File: 04-SF-1/101
Doyle Dr. Project Contract 3
04-163733

Subject: Request for Contract Change Order

This is to initiate a Contract Change Order request for replacing the light pedestal, VMS sign, construction signs to accommodate the Presidio Trust request and recommendation. (Please check all applicable boxes):

Brief Description of Work: Brief Description
Replacing the standard light poles and VMS signs to a new custom design.
This Contract Change Order is necessary due to the following: Why Change?
To accommodate the Presidio Trust request. Construction will resolve any cost related issue created by this CCO with the contractor in the field.

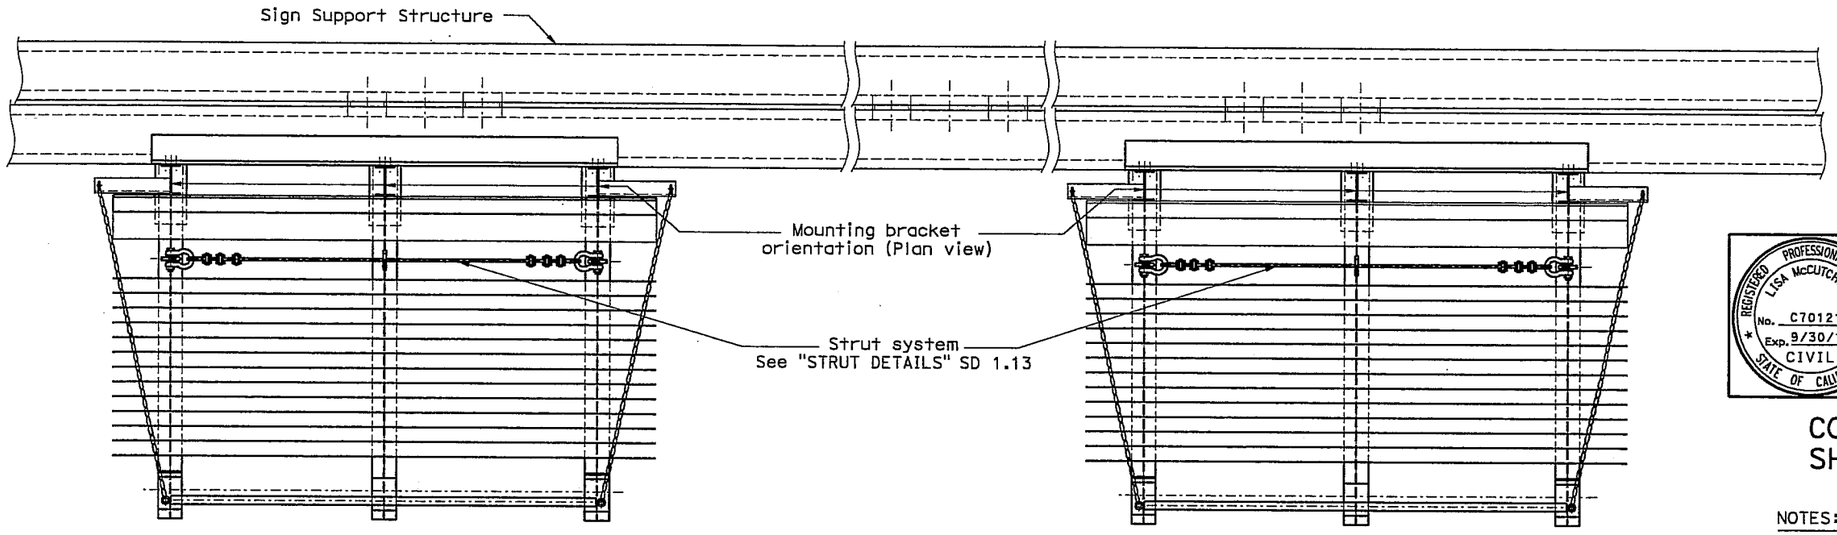
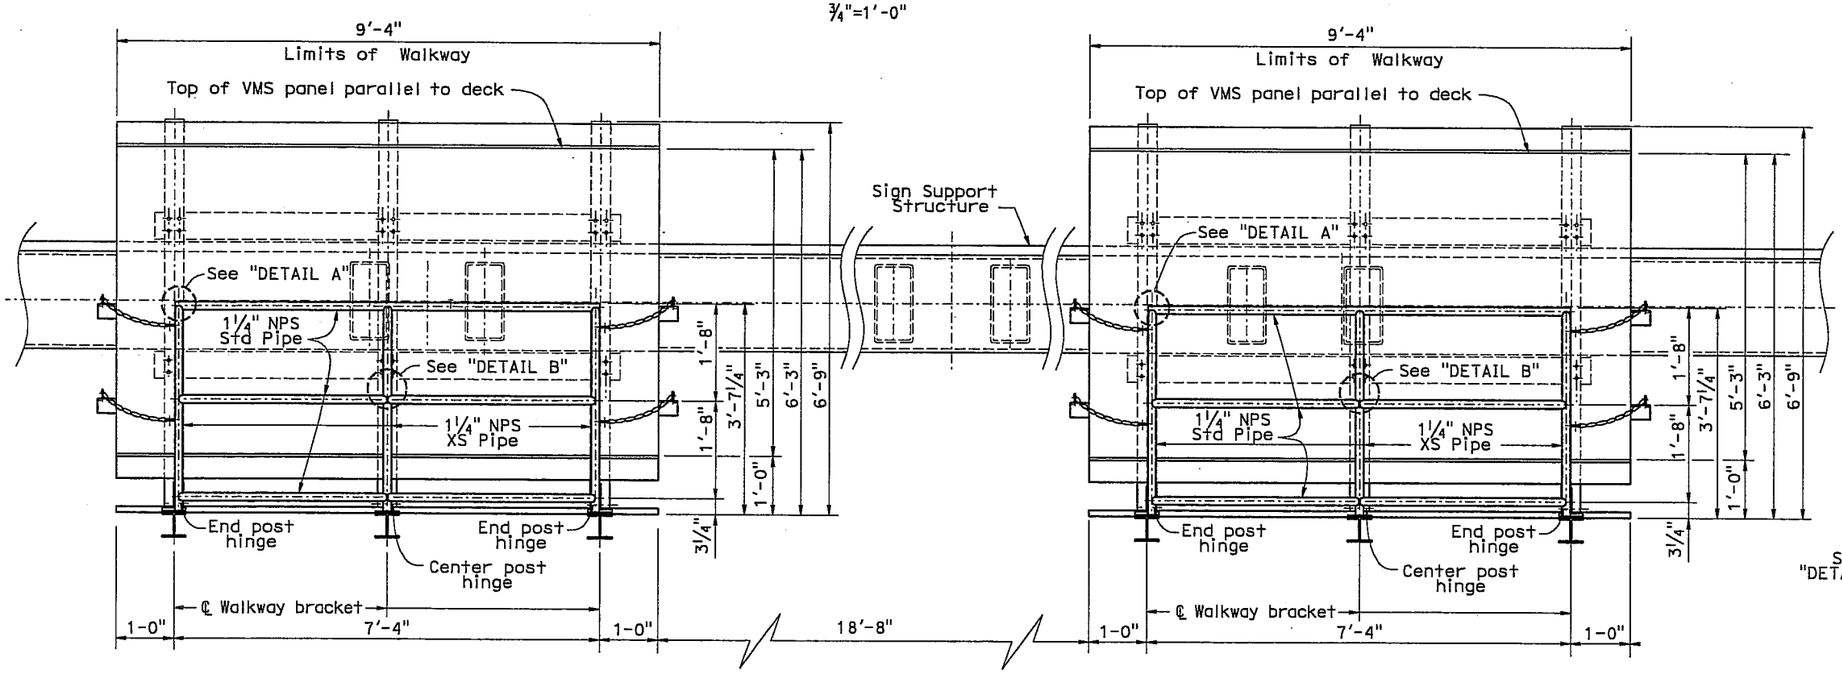
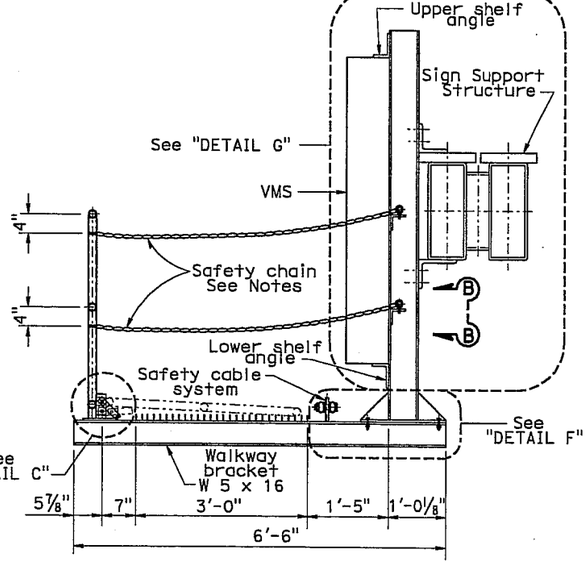
MARK	DATE	REVISION(S) DESCRIPTIONS	DES	CHK	DET
1	3-10-10	Revised Entire Sheet	LM		AD

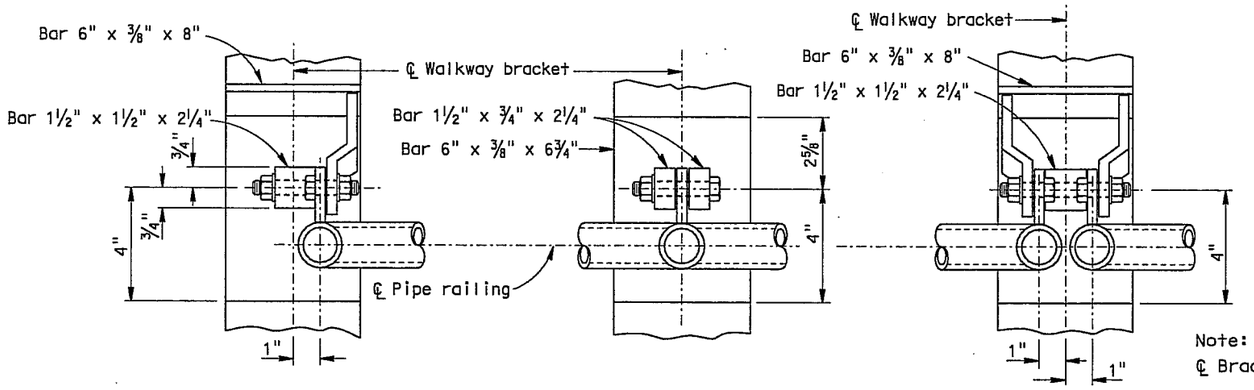
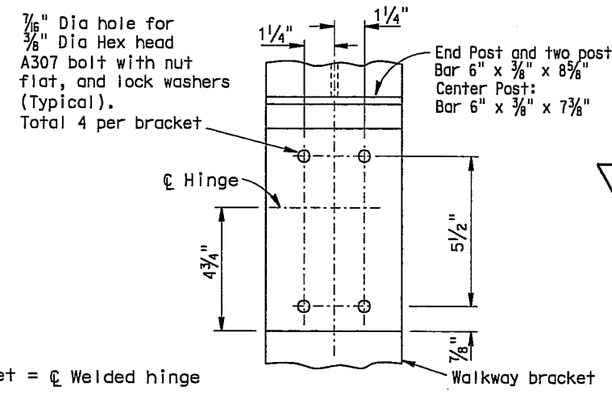
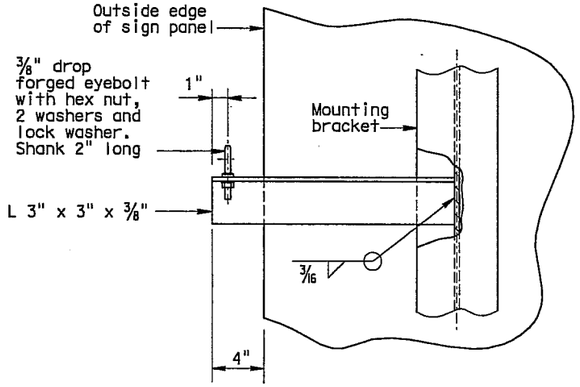
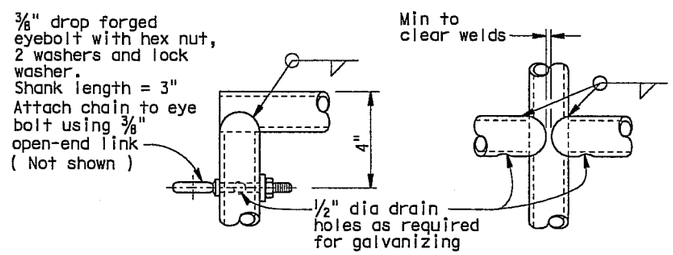
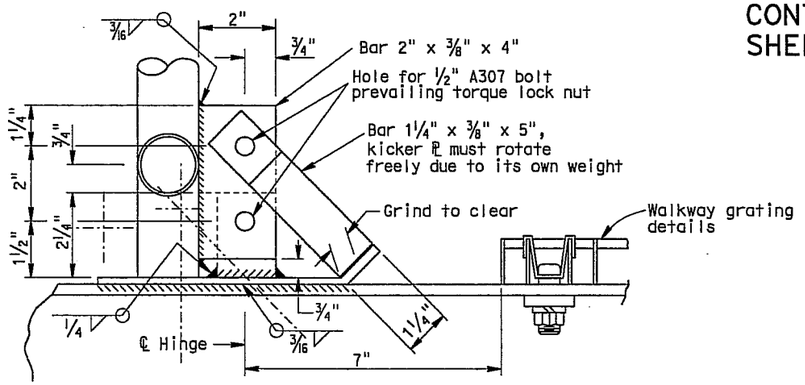
MARK	DATE	REVISION(S) DESCRIPTIONS	DES	CHK	DET
1	3-10-10	Revised Entire Sheet	LM		AD

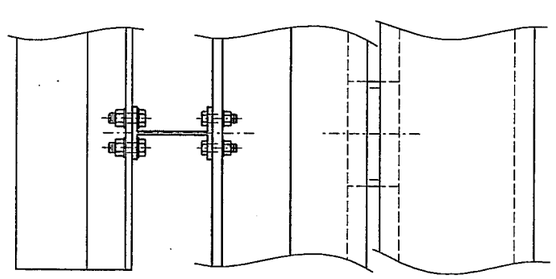
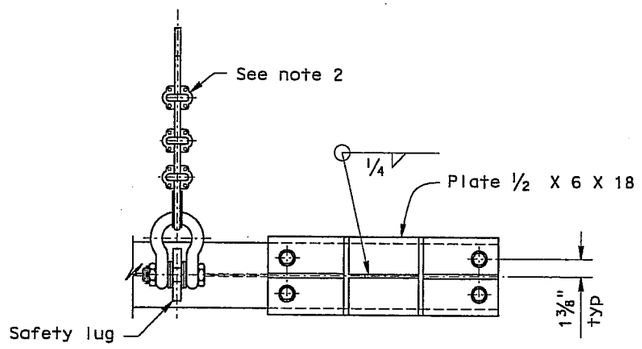
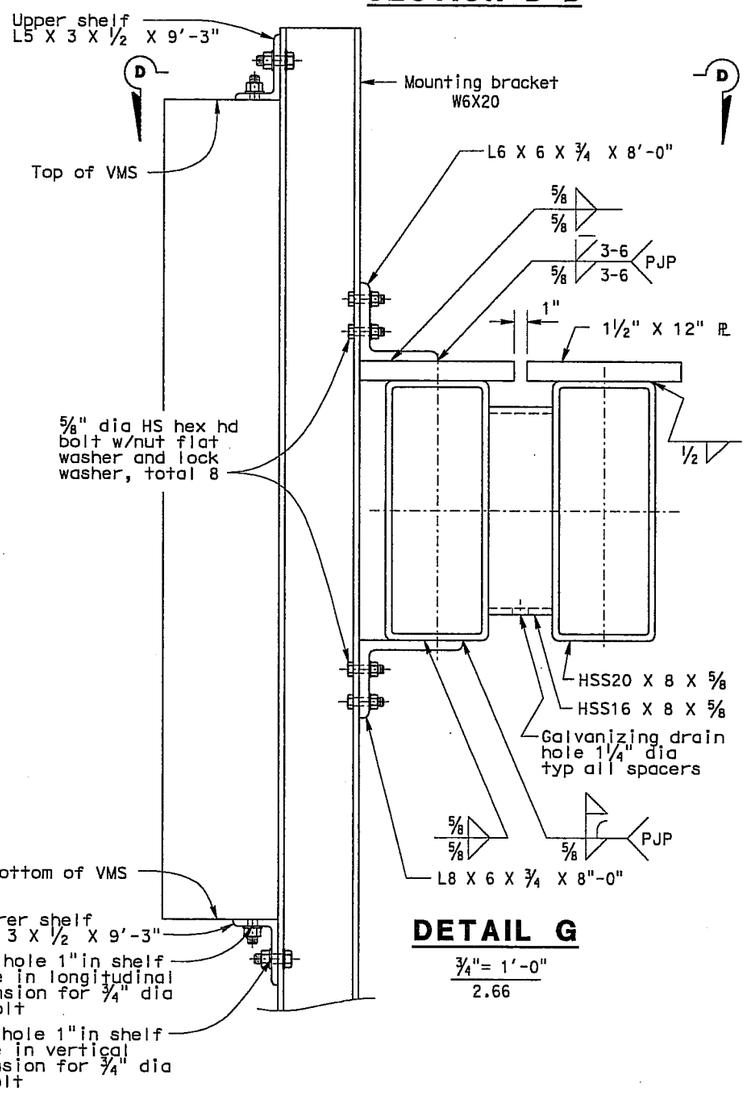
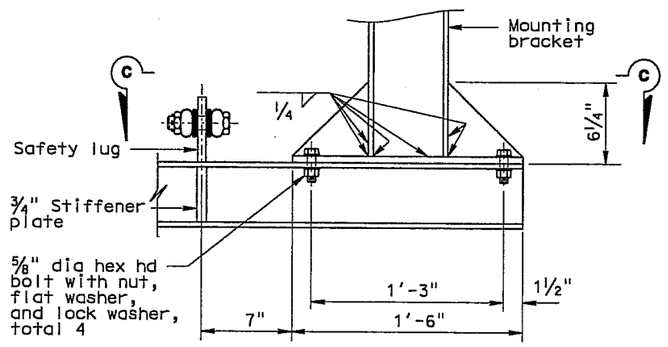
MARK	DATE	REVISION(S) DESCRIPTIONS	DES	CHK	DET
1	3-10-10	Revised Entire Sheet	LM		AD

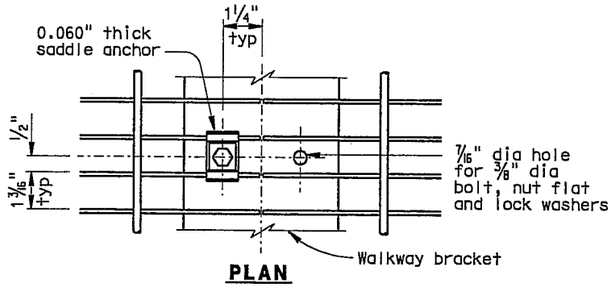
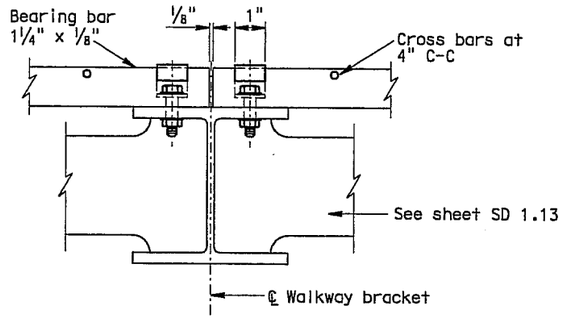
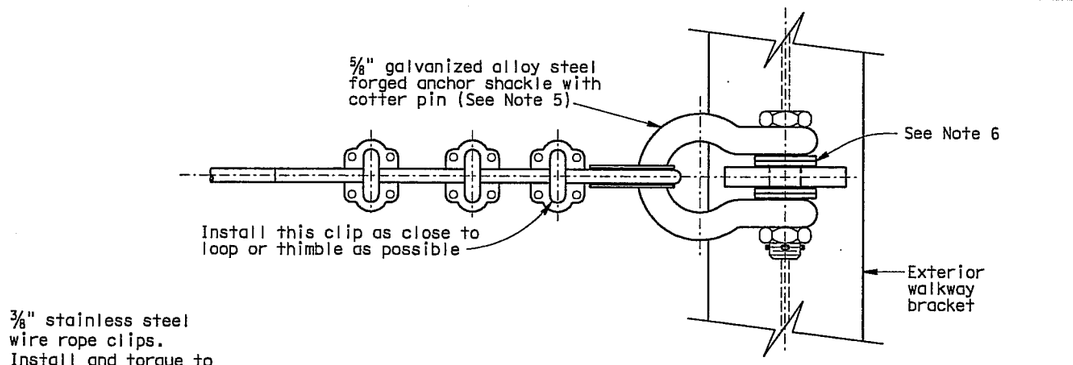
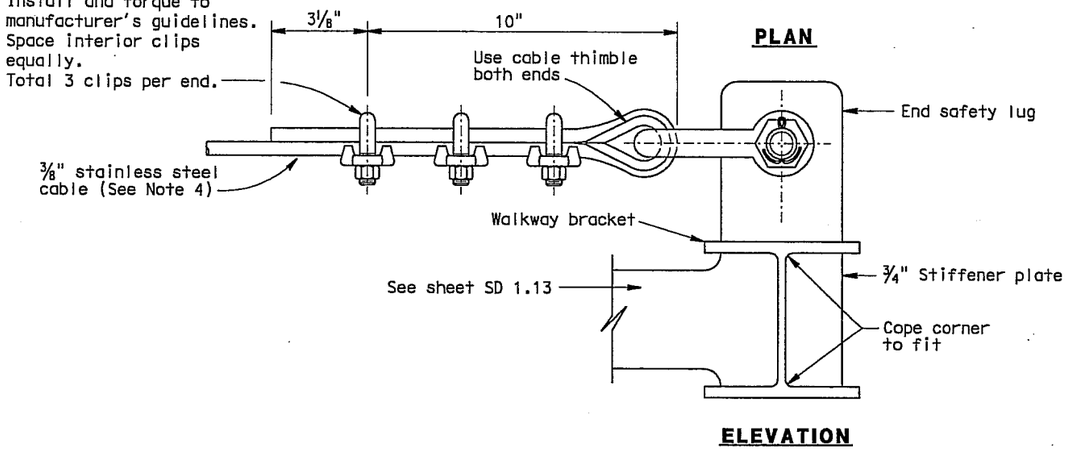
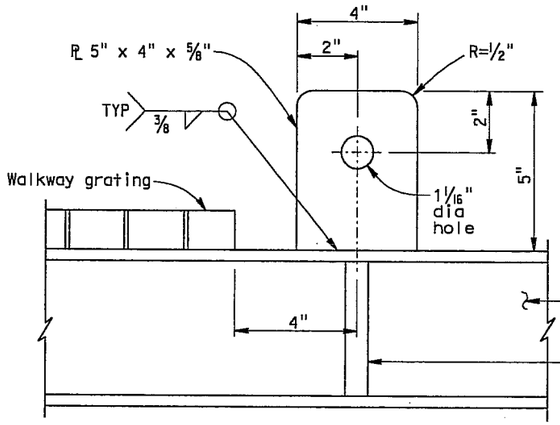
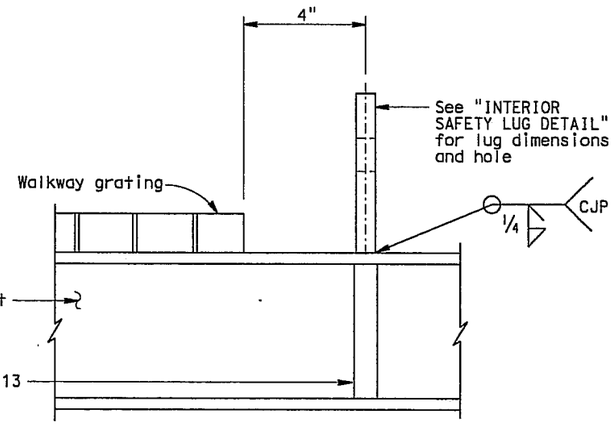
MARK	DATE	REVISION(S) DESCRIPTIONS	DES	CHK	DET
1	3-10-10	Revised Entire Sheet	LM		AD

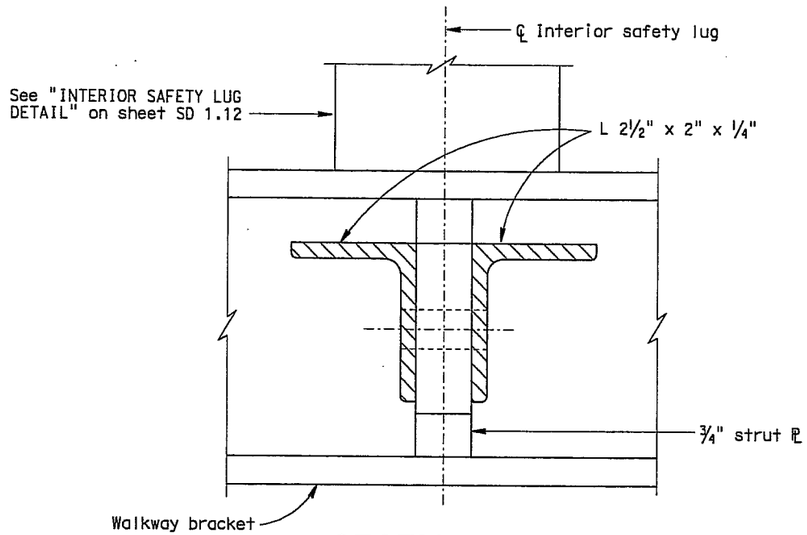
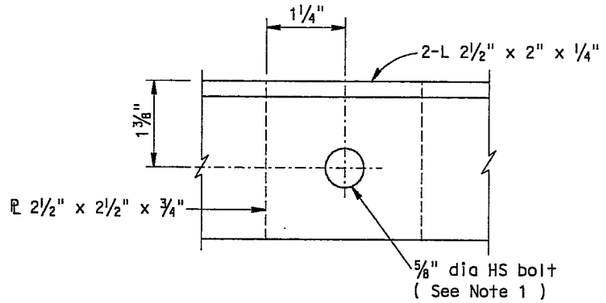
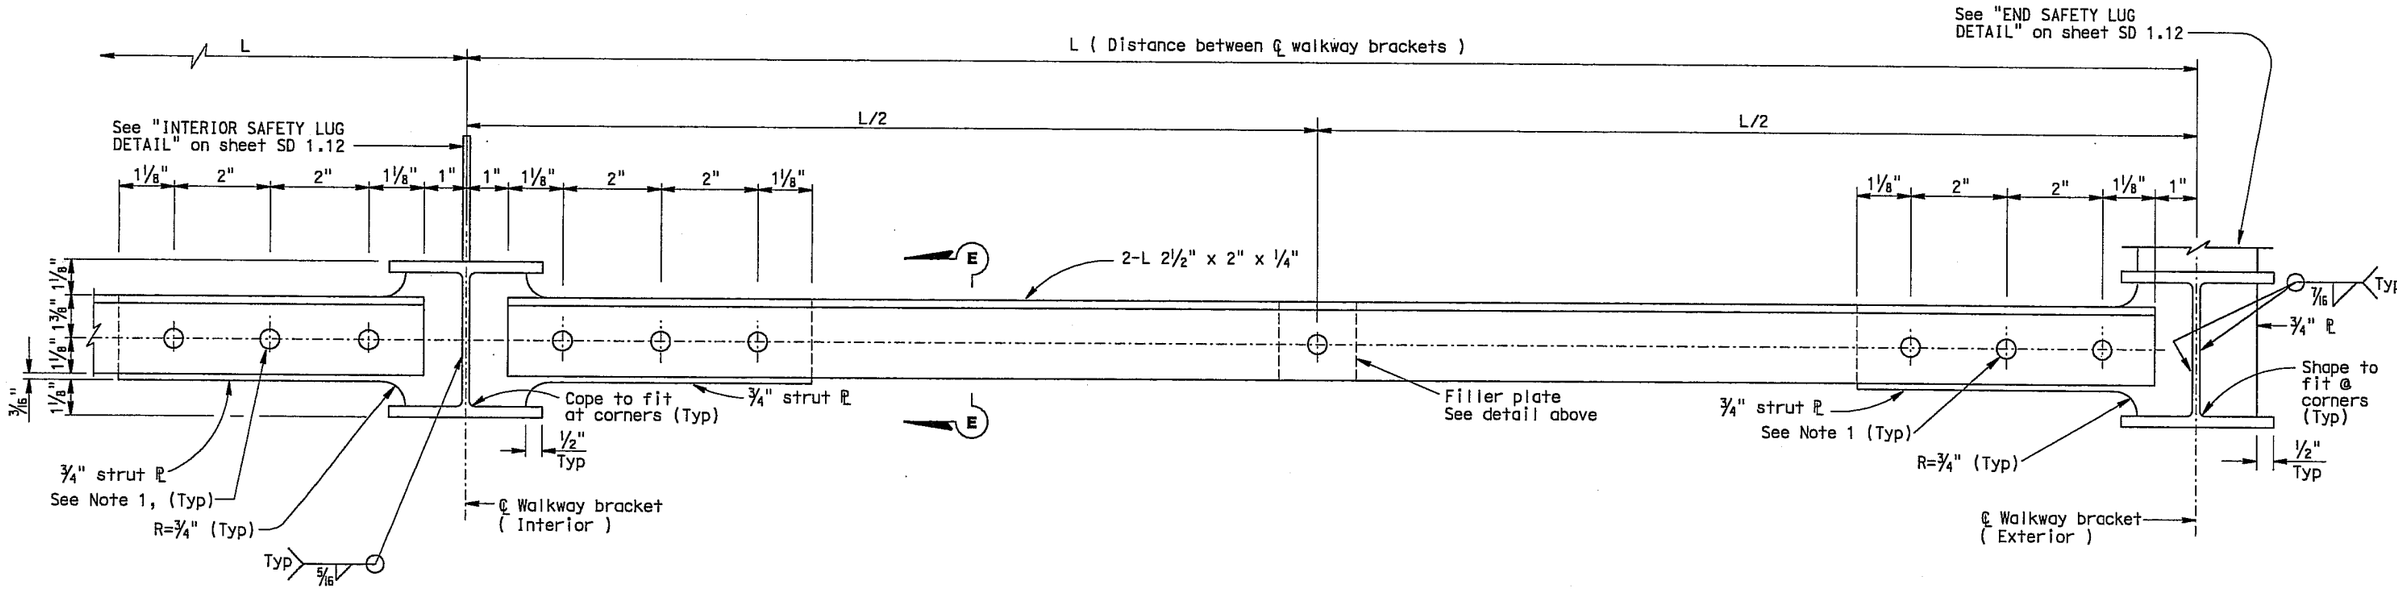
MARK	DATE	REVISION(S) DESCRIPTIONS	DES	CHK	DET
1	3-10-10	Revised Entire Sheet	LM		AD

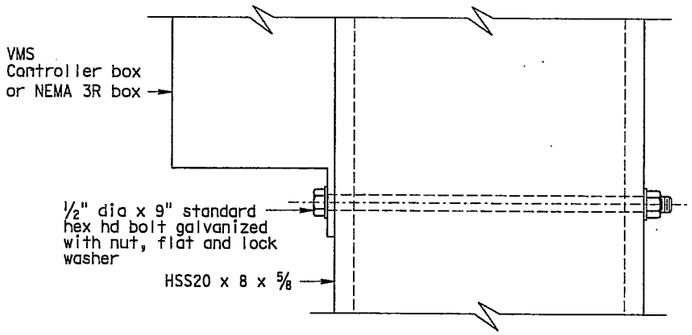
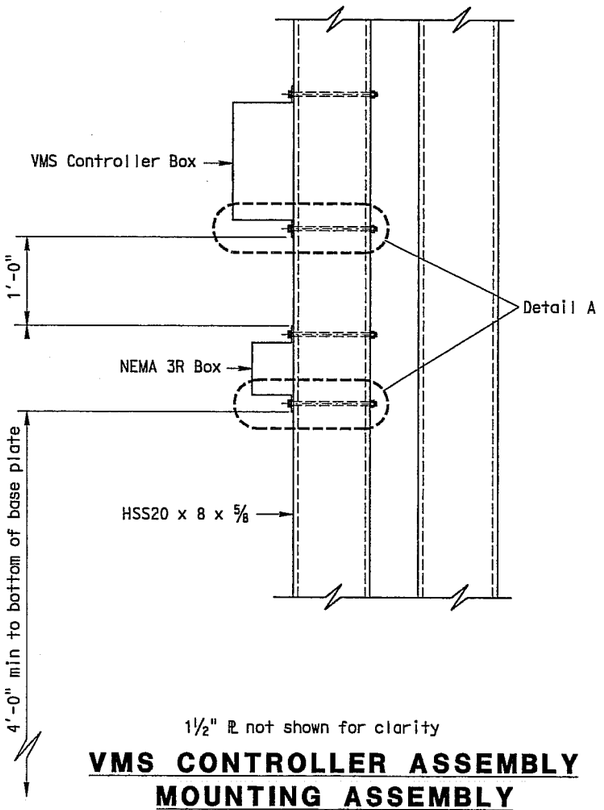
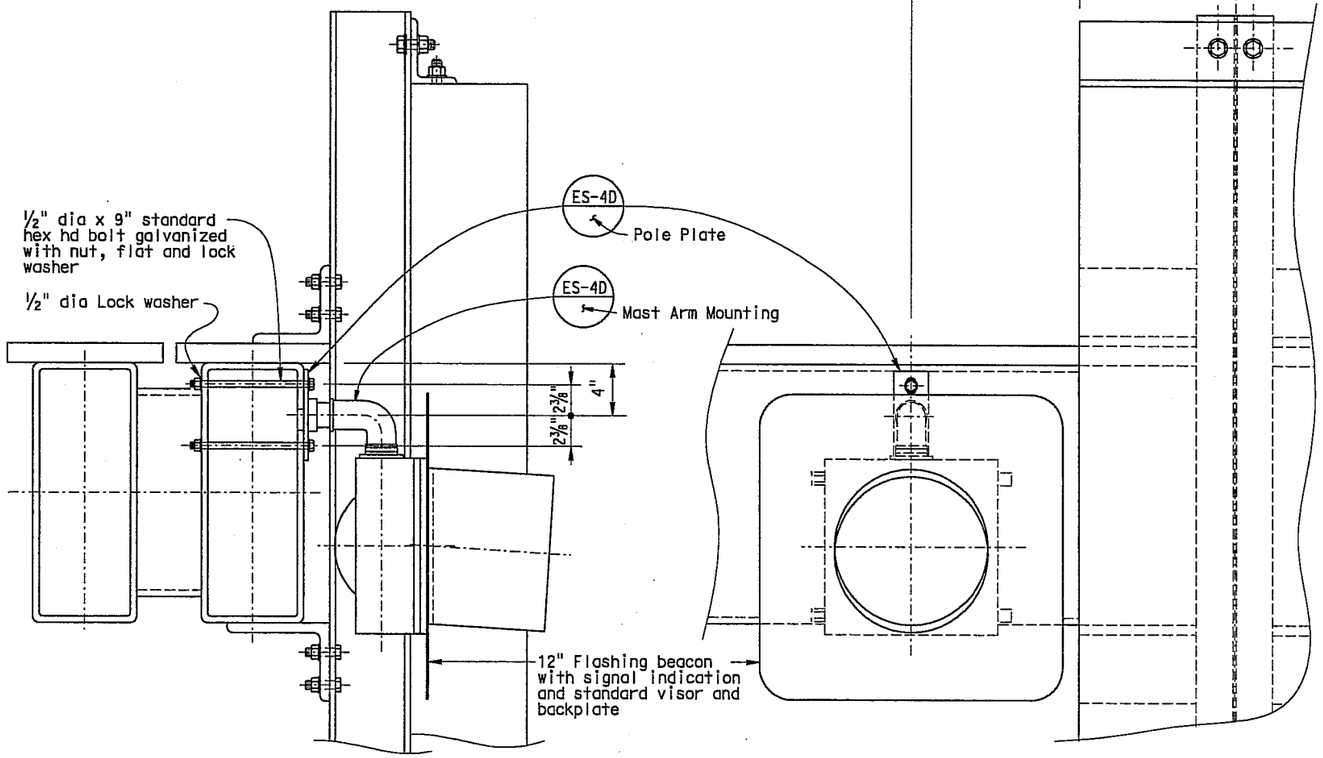
MARK	DATE	REVISION(S) DESCRIPTIONS	DES	CHK	DET
1	3-10-10	Revised Entire Sheet	LM		AD
